## Service Bulletin

S.B. No: 153

**Title:** SAB UNDERCARRIAGE NOSEWHEEL FORK INSPECTION**Classification:** This Service Bulletin has been classified by SAL as Recommended**Compliance:** At next 150 flying hour check**Applicability:** T67A Post Mod M136A, (SAB T9S), Pre Mod M468 and M791 (Introduction of Fairey Undercarriage) T67B, T67C Series, T67M, T67M-MkII and T67M200

**FIGURE 1**

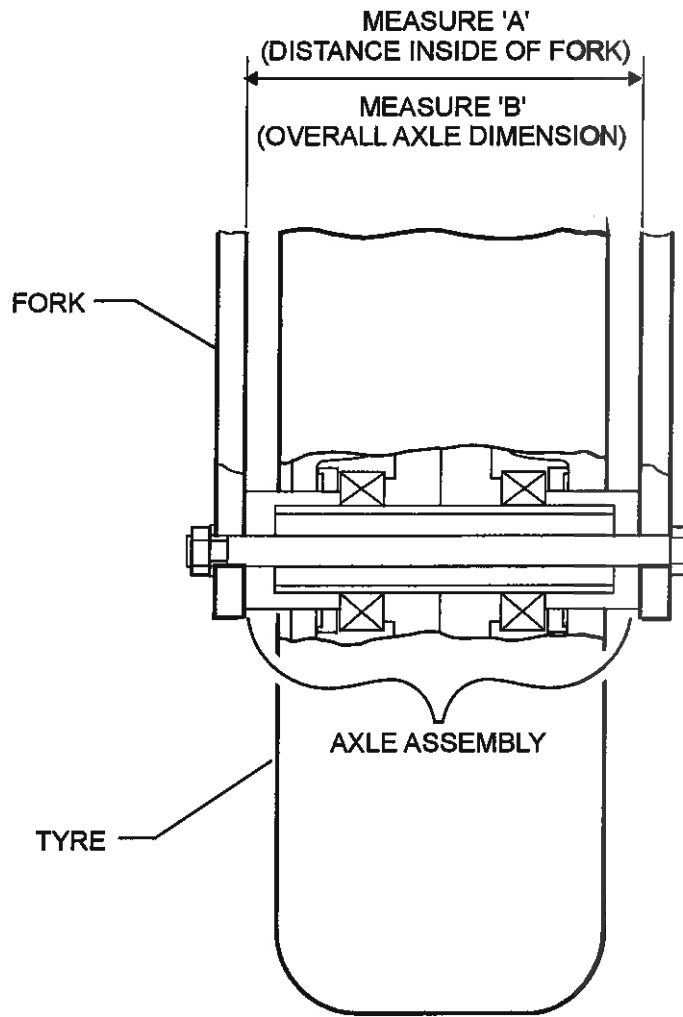
Cases have been reported of the space between the SAB nose undercarriage forks and the wheel axle being sufficiently wide to cause the forks to bend inwards when tight and ultimately cause the axle nut to loosen. This SB requires a one time inspection to determine the width of the gap and fitting of corrective spaces as applicable.

1. Check master switch, ignition switch and fuel are OFF. Disconnect external power and hangar aircraft as applicable.
2. Jack or hoist aircraft to bring nosewheel clear of ground with oleo pneumatic strut fully extended.
3. Place a suitable trestle support under bottom centre of fuselage 12 inches behind firewall.
4. Remove wheel stiffnut, withdraw axle bolt from axle fork and remove wheel assembly.
5. Leave wheel assembly together and clean outer surfaces of axle spacers and inner surfaces nosewheel forks.
6. Determine by measurement at axle centre line, the following dimensions, reg Fig, 1,
  - a. Measurement A: The distance between the inner faces of the nosewheel forks. Fork ideally should be parallel.
  - b. Measurement B: The dimension between the axle spacer outer faces when wheel assembly is pushed together, as on aircraft.

7.
  - i. If the difference between the two dimensions is less than 15mm, then no further action need be taken.
  - ii. If the difference between the two dimensions is 1.5mm to 4.0mm, then Mod M832 is to be incorporated.
  - iii. If the gap is between more than 4.00mm and 8.0mm, then Mod M998 is to be incorporated.
  - iv. If the gap is more than 8.0mm, then new fork is to be procured.
8. Annotate logbook "SB 153 complied with."
